SERVIS BULLETIN No. BB/52

- 1. WITH REFERENCE TO:** Hot-air balloons Kubicek (serial numbers: 1292, 1331, 1360, 1364, 1397)
- 2. REASON:** Possible occurrence of a weaving defect on a load tape
- 3. REQUIRED ACTION:** Checking up all the load tapes (White PES Tape 20 kN, width 25 mm, thickness 2,7mm, lined with black threads by sides)
- 4. DEADLINE FOR ACTION:** August 31, 2018
- 5. ACTION CARRIED OUT BY:** Maintenance organization authorized by national regulations
- 6. INDUCED COST COVERED:** Owner/Operator
- 7. NECESSARY MATERIAL:** In case of replacement: 2782.01 – White PES Tape, width 25 - for balloons, 20 kN
- 8. PROCESS:** Check all the load tapes and in case of finding a yellow thread carry out a repair according to MM, Chap. 3.3.
- 9. BULLETIN TAKES EFFECT:** July 23, 2018
- 10. ENCLOSURES:** 1. Example of a weaving defect marking

Enclosure 1

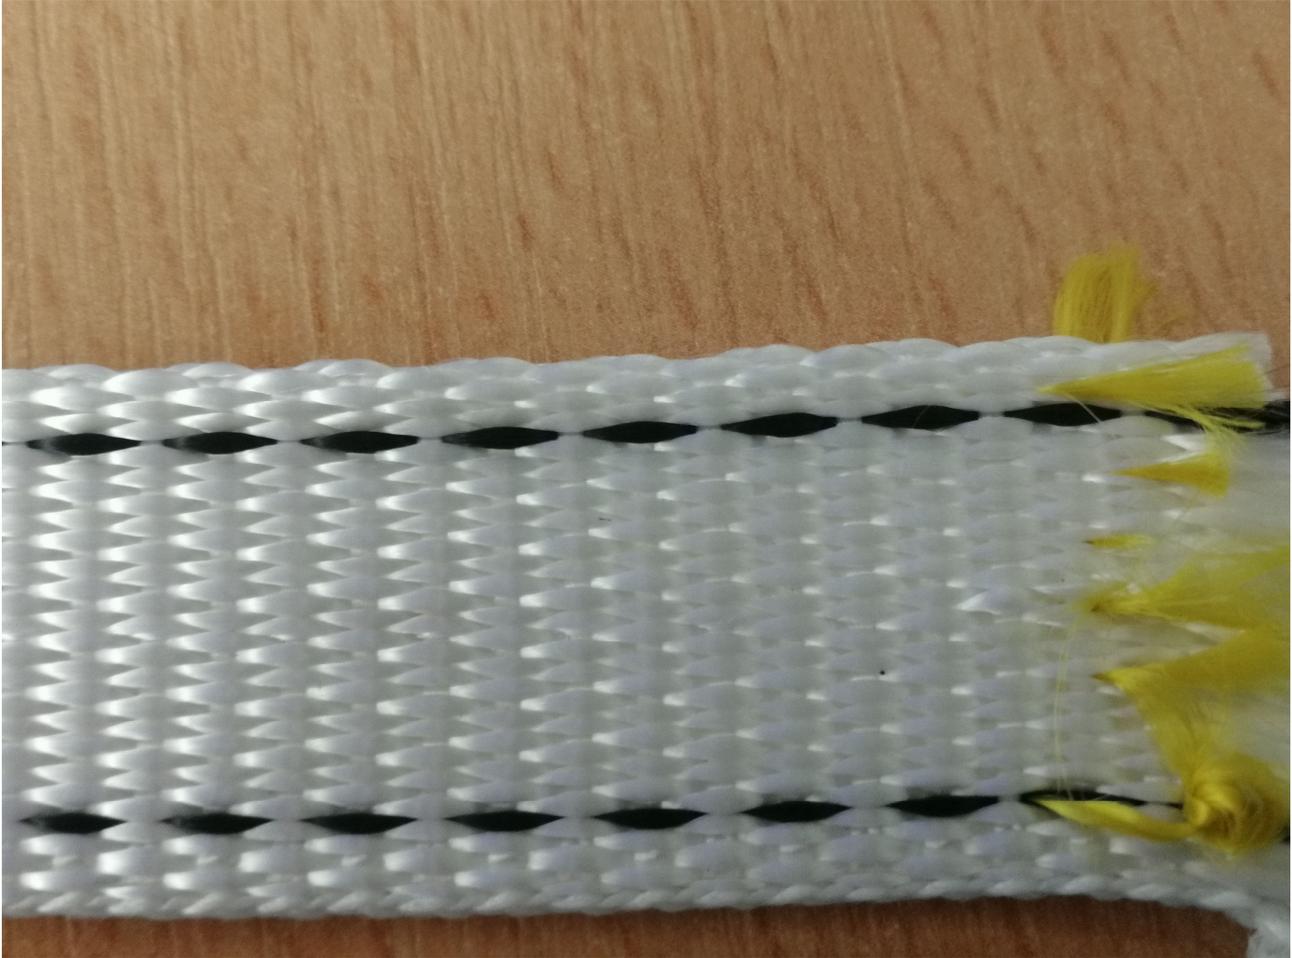
Example of a yellow thread marking of a weaving defect

Note: The yellow thread is not necessarily visible this way – it will be probably more integrated into the weaving.
